Conceptual Model to Support PCB Management and Monitoring in the Steinberger Slough/Redwood Creek Priority Margin Unit

Final Report

January 2021

Figure 4- 2. Steinberger Slough recovery with differing starting concentrations. South Bay mean SSC and PCBs, constant watershed loading, other variables from open Bay 1-box PCB model (15cm mixed layer, 1m/d settling, 2 mm/y burial, etc.).

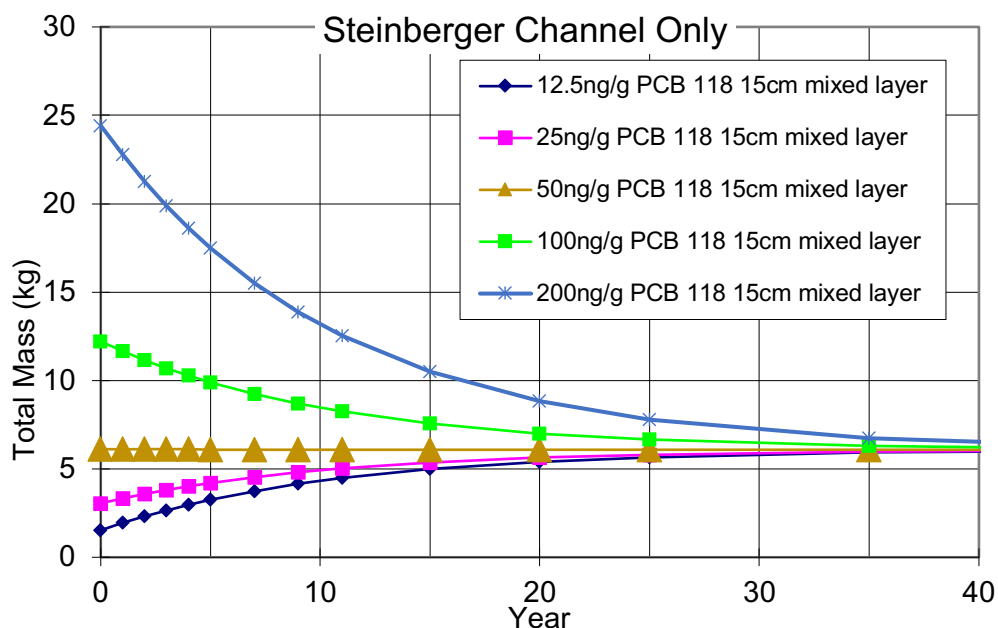
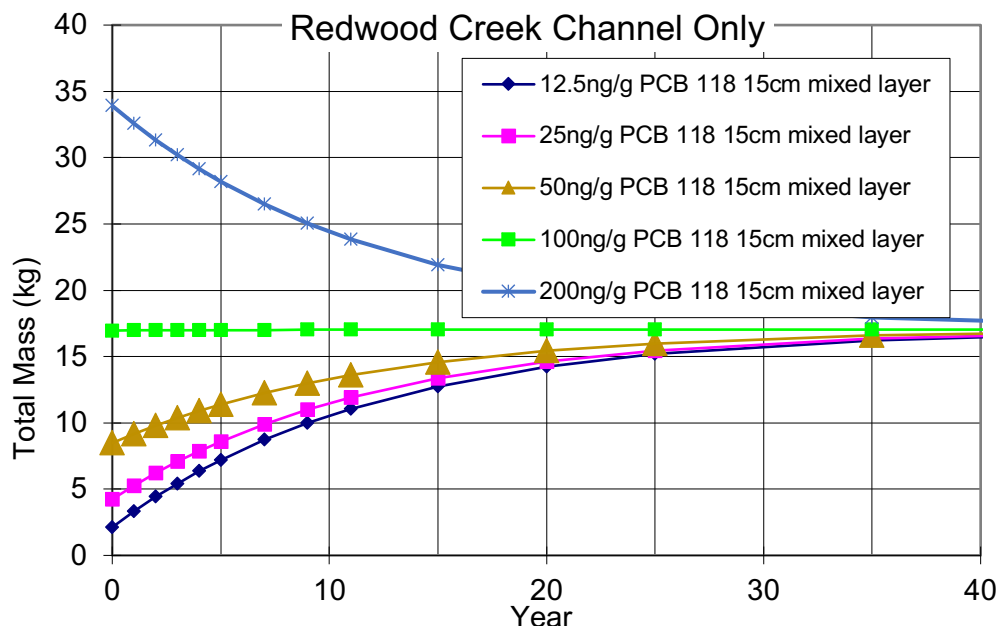
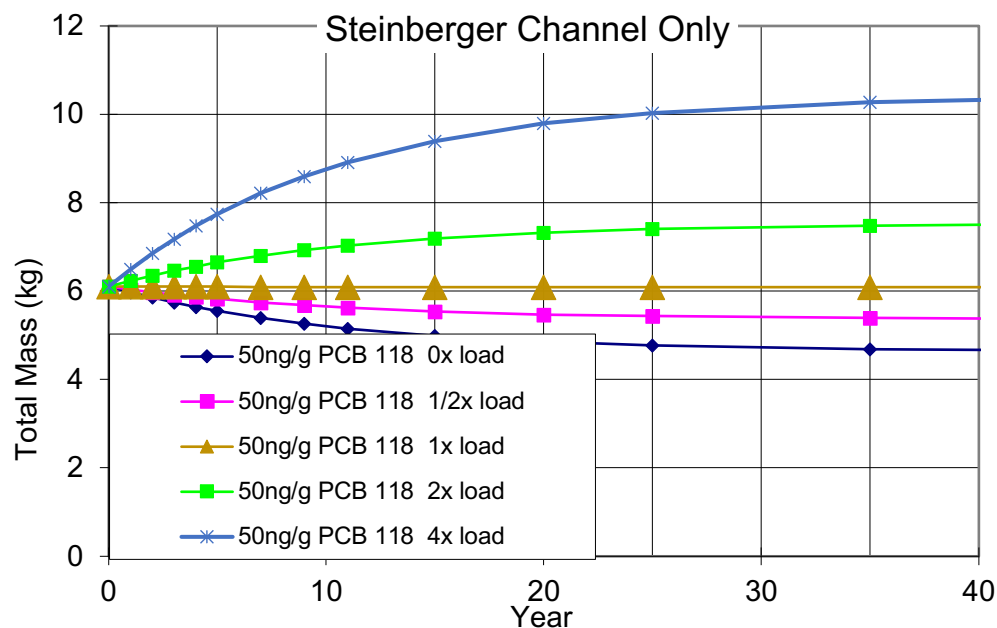
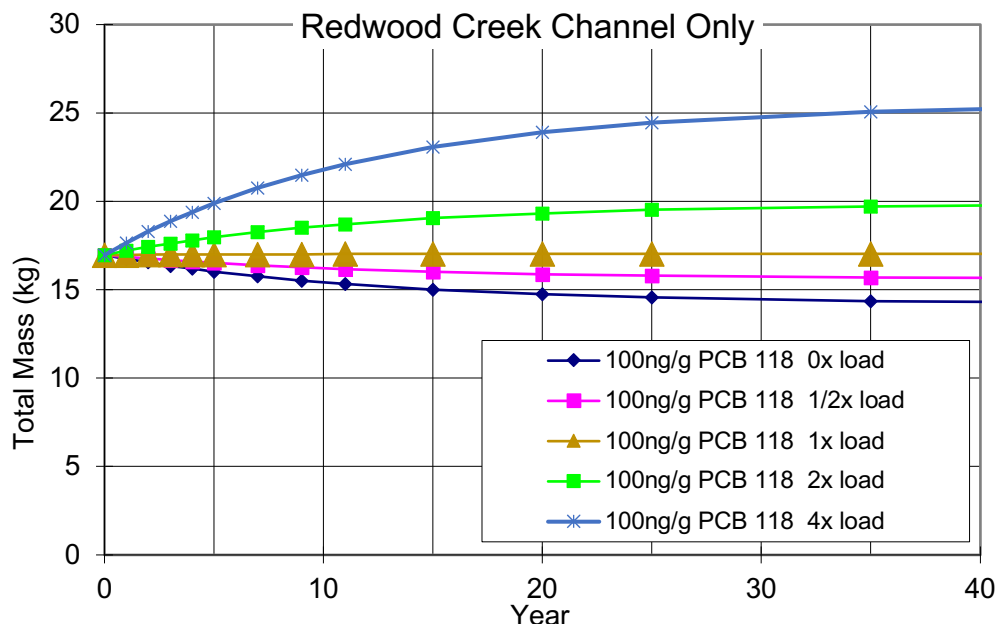
7. Figures 4-2 through 4-5; I get that 4-4 and 4-5 show that SS/RC will recover better if we reduce the loading from the watersheds, but am I correct in interpreting Figures 4-2 and 4-3 as demonstrating that each creek is already at steady state?

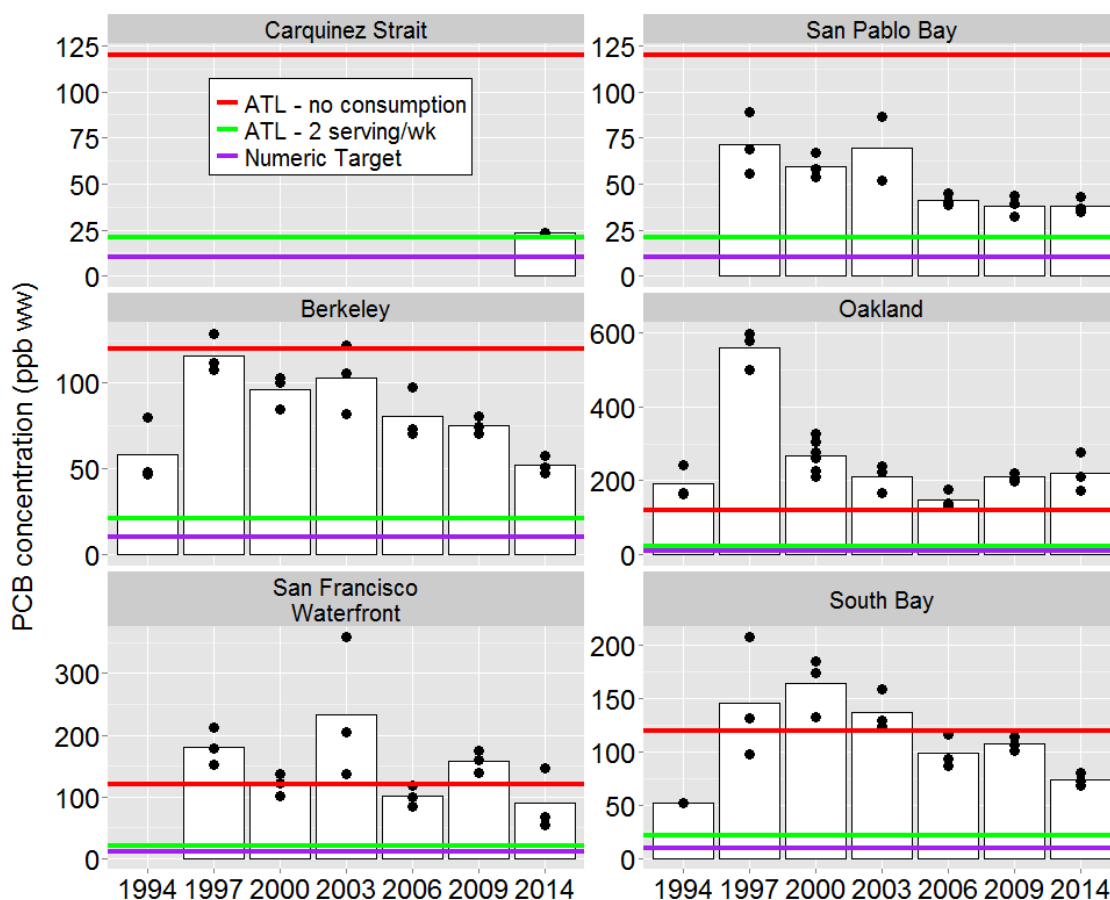
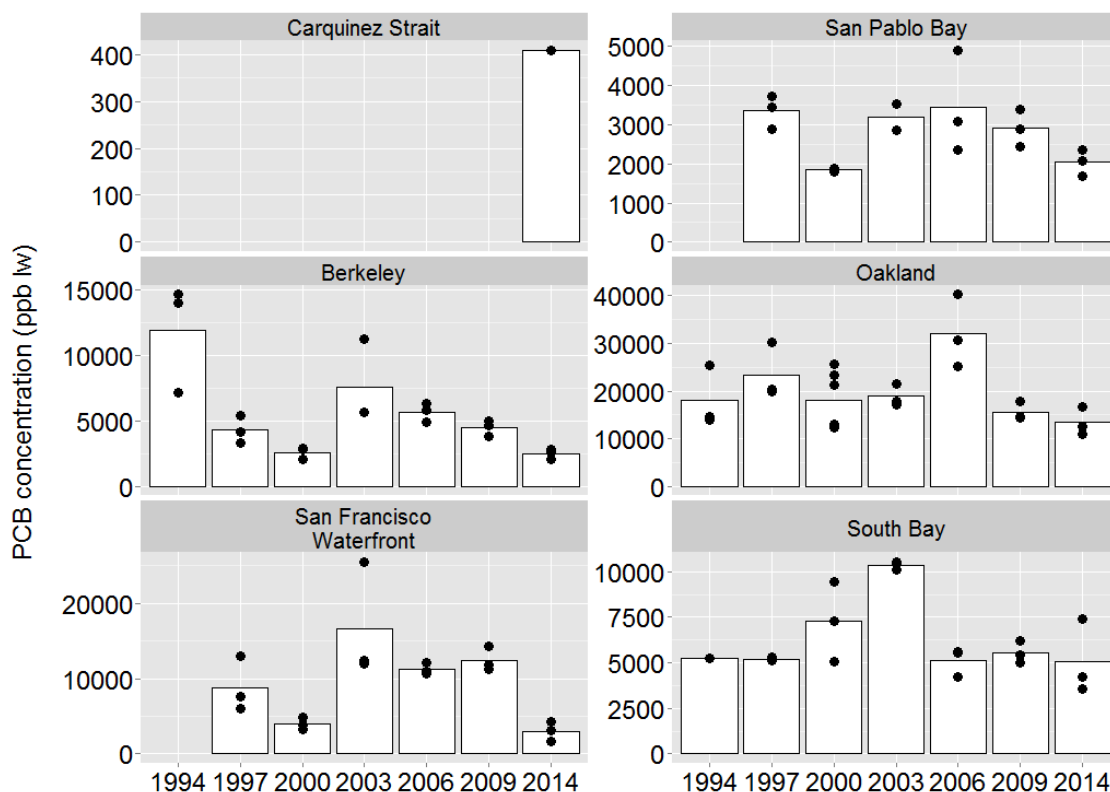
9. Is the only difference between Figure 5-7 and Figure 5-9 the change from wet weight to lipid-normalized weight? I know that's obvious when you refer to the figures while reading the text, but if a lazy reader is just paging through the figures it might be good to emphasize that difference more in the captions.
